April 10, 2019
BOARD OF COUNTY COMMISSIONERS
ORANGE COUNTY, FLORIDA
ADDENDUM NO. 2 / IFB NO. Y19-747-RC
ORANGE COUNTY SHERIFF'S OFFICE COC IT SERVICES AREA REMODEL

OC SHERIFF'S OFFICE IT SERVICES RENOVATION

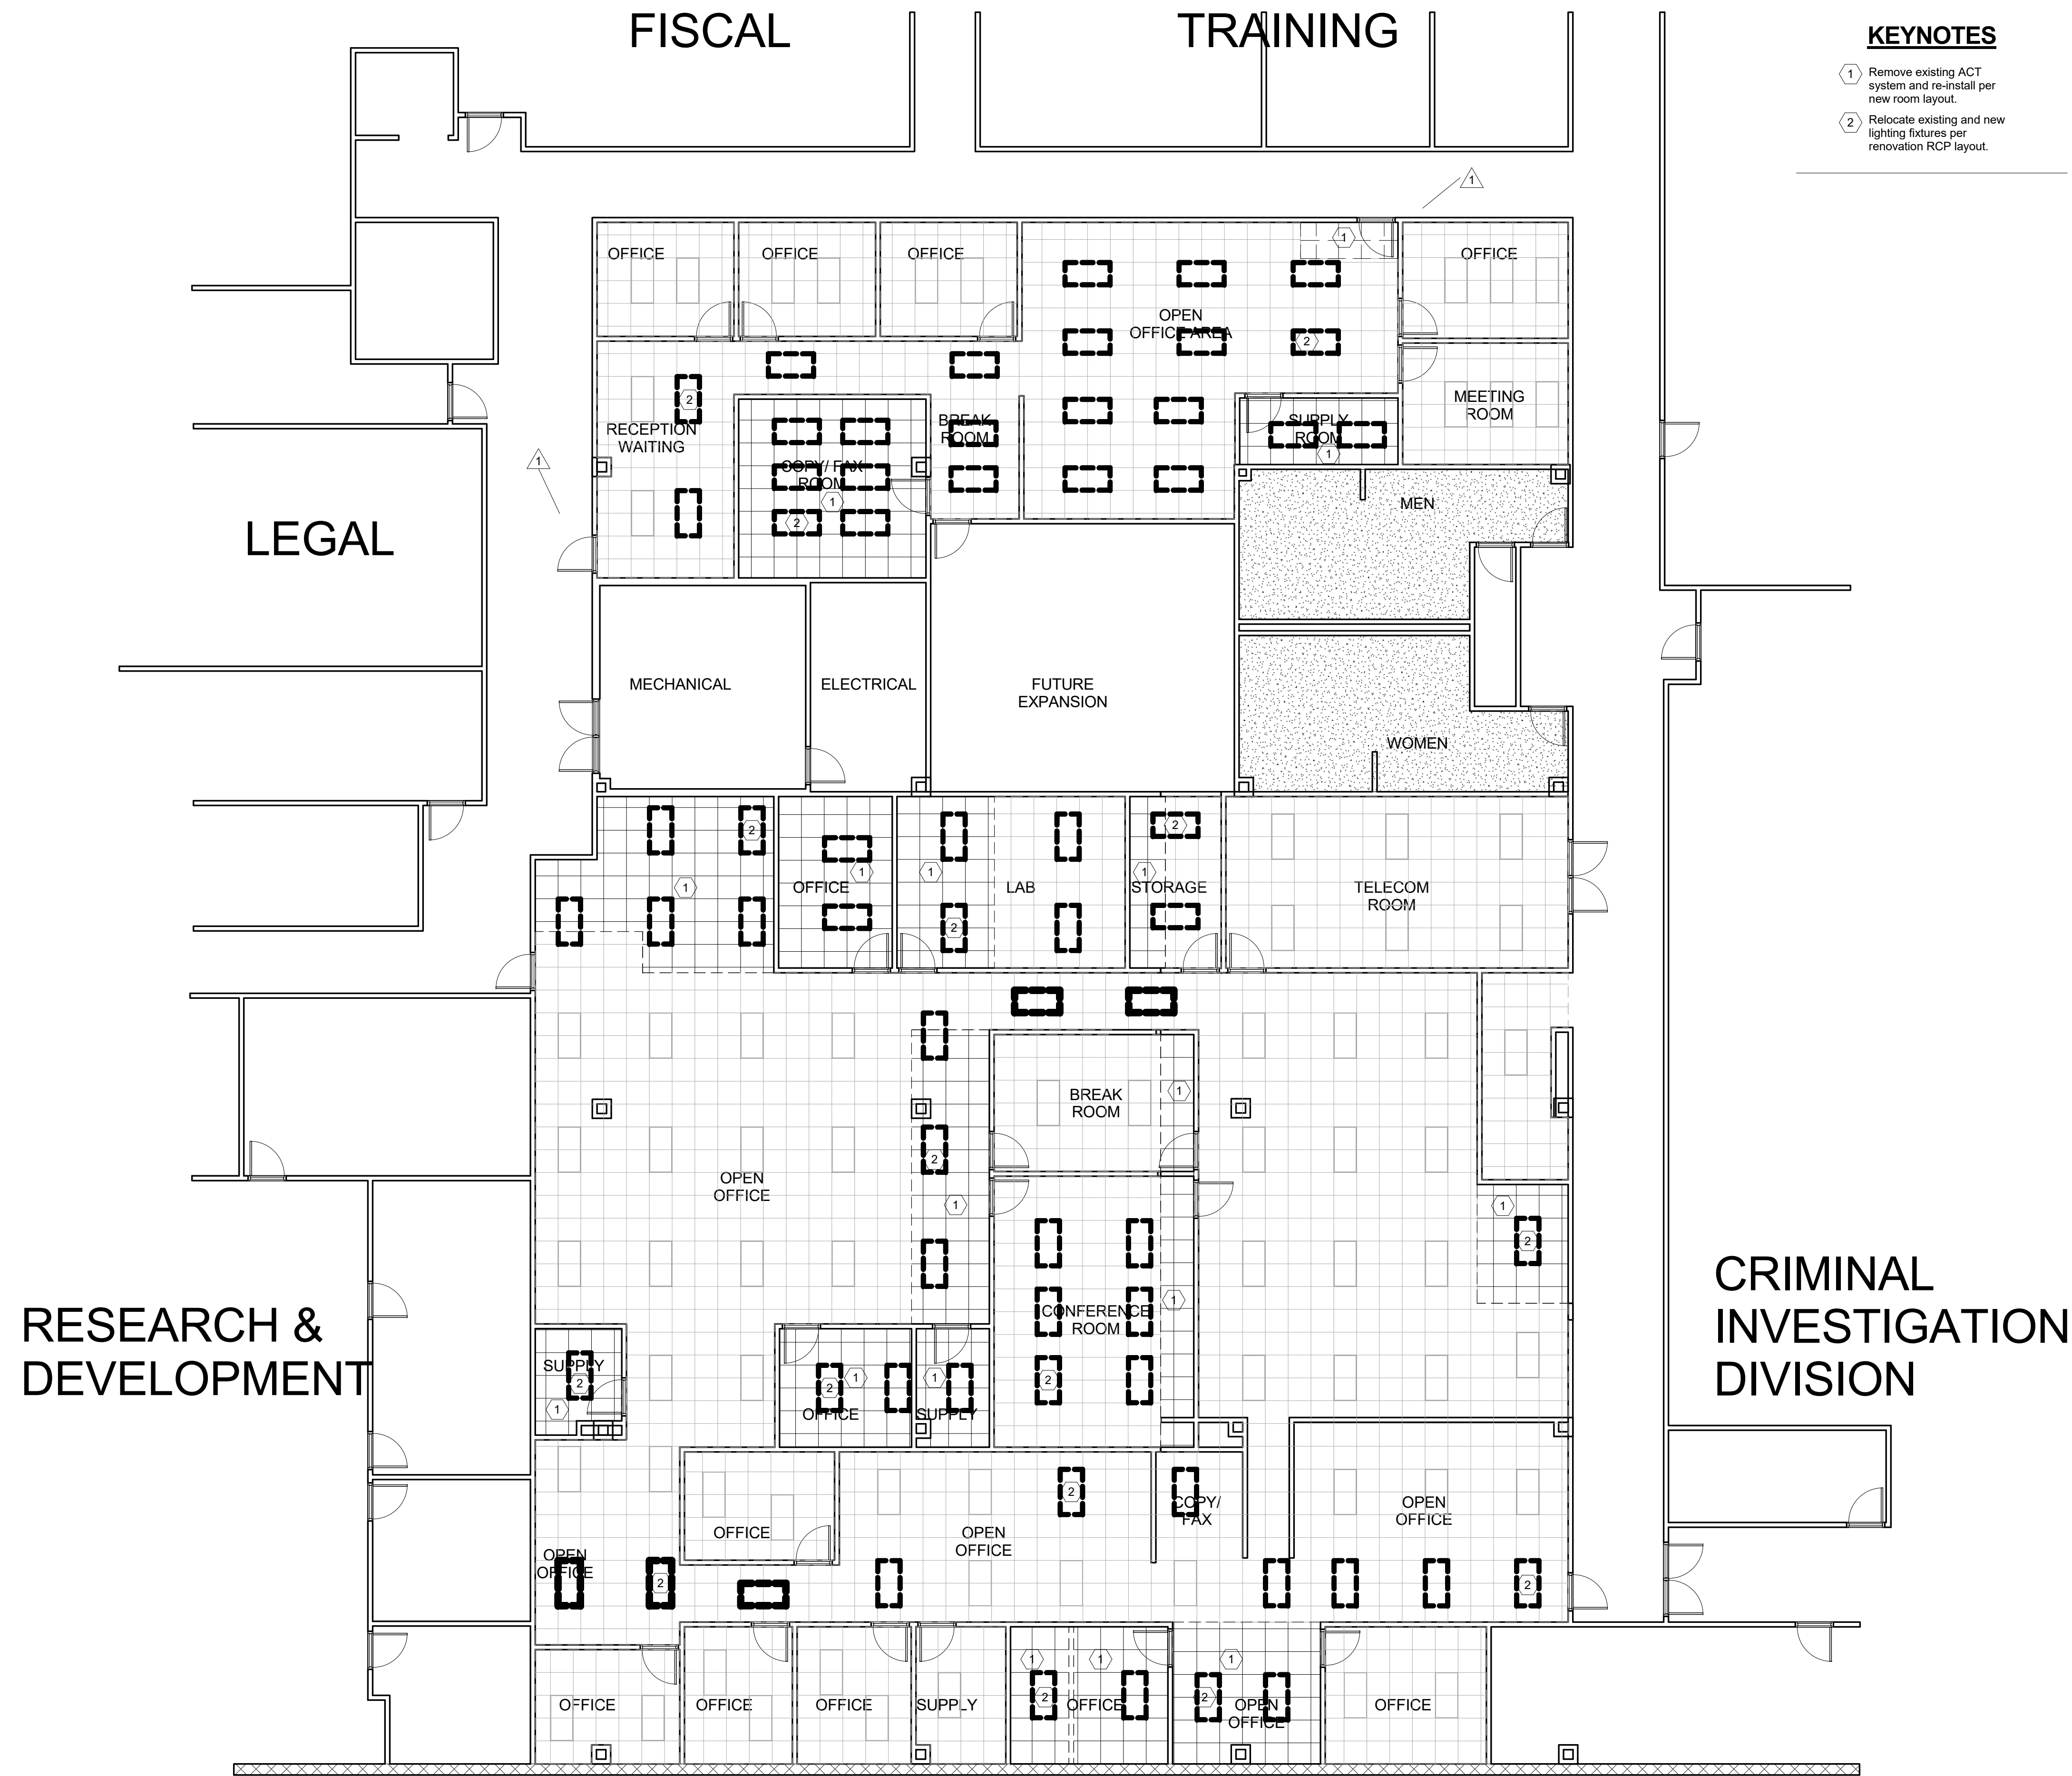
1. **Question:** Sheets A110 and A111 have no keynotes for the extent of demolition and replacement of ACT ceiling system. Can you provide?

Answer: See attached revised A110 sheet.

- KEYNOTES**
- 1 Remove existing ACT system and re-install per new room layout.
 - 2 Relocate existing and new lighting fixtures per renovation RCP layout.
